**BOARD OF ZONING ADJUSTMENT
STAFF REPORT****Date: July 12, 2021****CASE NUMBER**

6398

Barton & Shumer Engineering, LLC

LOCATION2600 First Avenue
(Northwest corner of First Avenue and Jessie Street).**VARIANCE REQUEST****USE:** To allow a grocery/convenience store in an R-1, Single-Family Residential District.**SIDE STREET SIDE YARD SETBACK:** Reduced side street side yard setbacks in an R-1, Single-Family Residential District.**DUMPSTER SETBACK:** Reduced dumpster setbacks in an R-1, Single-Family Residential District.**RESIDENTIAL BUFFER:** No on-site residential buffer in an R-1, Single-Family Residential District.**OFF-STREET LOADING:** No off-street loading area in an R-1, Single-Family Residential District.**PARKING LOT SCREENING:** No parking lot screening in an R-1, Single-Family Residential District.**TREE PLANTING:** To allow no tree plantings in an R-1, Single-Family Residential District.**ZONING ORDINANCE
REQUIREMENT****USE:** The Zoning Ordinance does not allow a grocery/convenience store in an R-1, Single-Family Residential District.**SIDE STREET SIDE YARD SETBACK:** The Zoning Ordinance requires compliance with side street side yard setbacks in an R-1, Single-Fami

SITE PLAN

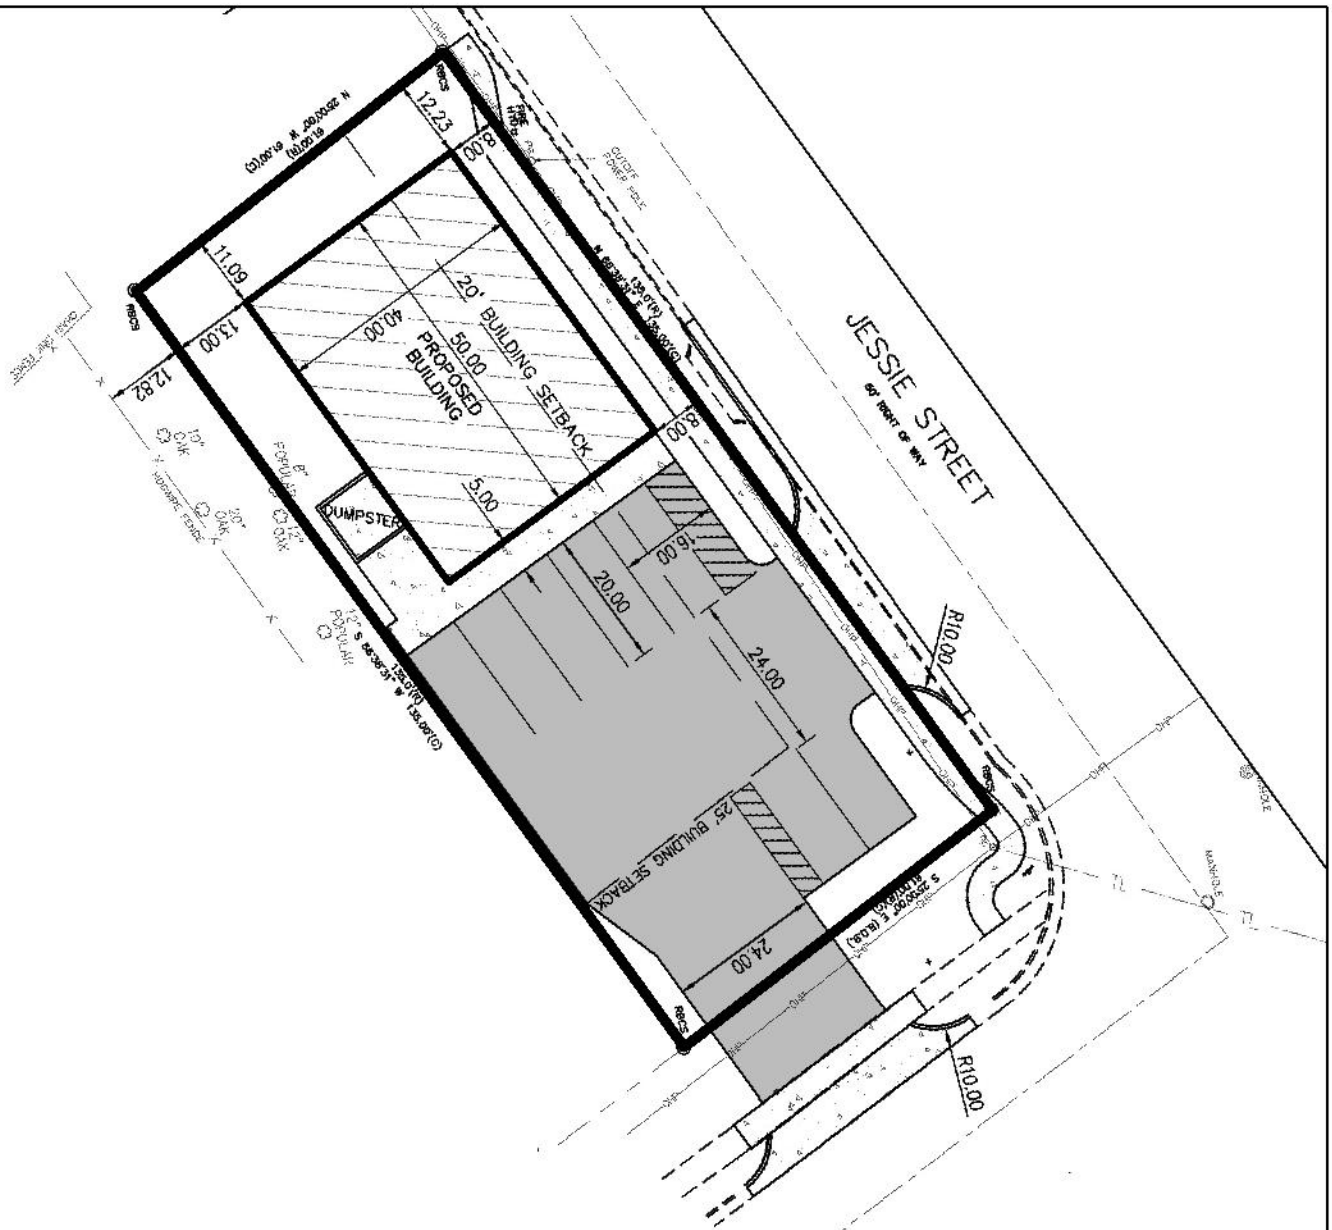
The applicant wishes to construct the new building approximately eight-feet from the side street side yard, where a 20-foot setback is required. The proposed 2,000 square foot structure could be reduced in size (approximately 600 square feet) in order to meet this requirement.

In regards to the dumpster location, it is depicted as being located approximately three-feet from the residential property to the South of the site, where the Zoning Ordinance requires a minimum of ten-feet. Again, if the proposed structure were reduced in size, there could be sufficient room for the dumpster to comply with setback requirements. Alternatively, the applicant could use curb side waste removal.

The applicant wishes to place a residential buffer on what is referred to in the narrative as “the historically accepted property line”, rather than the actual property line, and states that they have the approval of the adjacent property owner to do so. However, if the residential buffer is not installed on the subject site, it may create issues relating to maintenance down the road if either property is sold. If the applicant wishes to utilize the accepted lot line, rather than the official lot line, a two-lot subdivision application should be submitted to alter the official property lines; this may also help reduce the number of variances needed for the proposal.

The applicant is not proposing any off-street loading area for trucks delivering goods to be sold at the proposed business. While large trucks may not be anticipated to service the proposed business, it is impossible to anticipate the types of vehicles all future vendors will bring to the site. If a vehicle larger than a standard passenger vehicle is to service the site, it would block parking spaces, and make maneuvering on the site difficult.

The applicant states that they are requesting relief from parking lot screening, however, Section 64-6.A.3.i. of the Zoning Ordinance only requires screening to be provided for parking lots with ten or more cars. As the proposed development will have seven parking spaces, parking lot screening will not be required, making that request moot.

As it relates to tree plantings, the site is depicted as having a compliant amount of landscaped area, however, there are few places where a newly planted tree would have sufficient room to thrive. The Zoning Ordinance requires the site to have six frontage trees, six perimeter trees, and one parking tree, for a total of 13 trees; the applicant wishes to have no trees planted. If the Board is

Finally, while the site has historically been used commercially, the proposed site plan can be revised to comply with the Zoning Ordinance to a greater extent than illustrated on the site plan submitted. Moreover, the subject site could easily be used residentially without the need for variances.

inclined to approve the request, the applicant should coordinate with Urban Forestry in regards to tree plantings or making donations to the Tree Bank.

RECOMMENDATION: Based on the preceding, staff recommends to the Board the following findings of fact for Denial for the Variance requests:
